# PCN Report

**Prepared By** : Maggie Xu, Thyristor Product Engineer  
**Date** : February 7<sup>th</sup>, 2018  
**Products** : Thyristor Products acquired from ON Semiconductor  
**Revision** : A

This report covers manufacturing site transfer activities of Thyristor products acquired from ON Semiconductor. Site transfer includes backend assembly, final test and packaging operations.

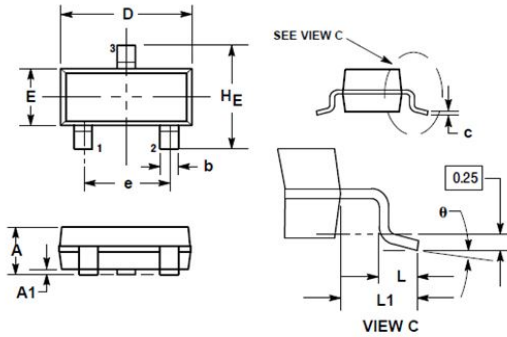
Format of Date code section of component marking is changed as follows.

PACKAGE	Date Code Format by ON Semiconductor (Old)	Date Code Format by Littelfuse (New)	Symbols
SOT23	M	YMA	Y: Year of Manufacturing M: Month of Manufacturing WW: Week of manufacturing A: Assembly location XX: Lot serial code
SOT223	AYW	YMA	
TO-225AA	YWW	YMAXX	
TO-251	YWW	YMAXX	
TO-252	YWW	YMAXX	
TO-220 Iso	AYWW	YMAXX	
TO-220AB	AYWW	YMAXX

##### 4.2 SOT223 Outline

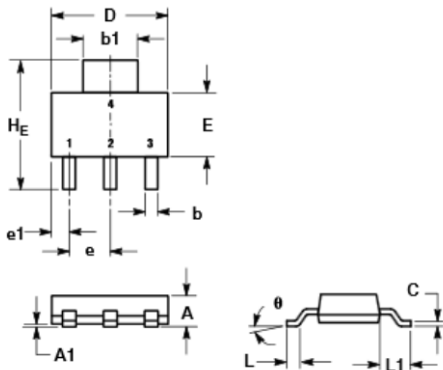
---Dimensions A, A1, c, D, e1 are different.

DIM	ON Semi Specification			Littelfuse Specification (New)		
	MILLIMETERS			MILLIMETERS		
	MIN	NOM	MAX	MIN	NOM	MAX
A	1.50	1.63	1.75	-	-	1.80
A1	0.02	0.60	0.10	0.02	0.07	0.13
b	0.60	0.75	0.89	0.66	0.75	0.84
b1	2.90	3.06	3.20	2.90	3.00	3.10
c	0.24	0.29	0.35	0.23	0.29	0.35
D	6.30	6.50	6.70	6.60	6.60	6.71
E	3.30	3.50	3.70	3.30	3.50	3.70
e	2.20	2.30	2.40	2.30 BSC		
e1	0.85	0.94	1.05	0.75	0.95	1.15
L1	1.50	1.75	2.00	1.50	1.75	2.00
He	6.70	7.00	7.30	6.80	7.00	7.20
∅	0°	-	10°	0°	-	10°
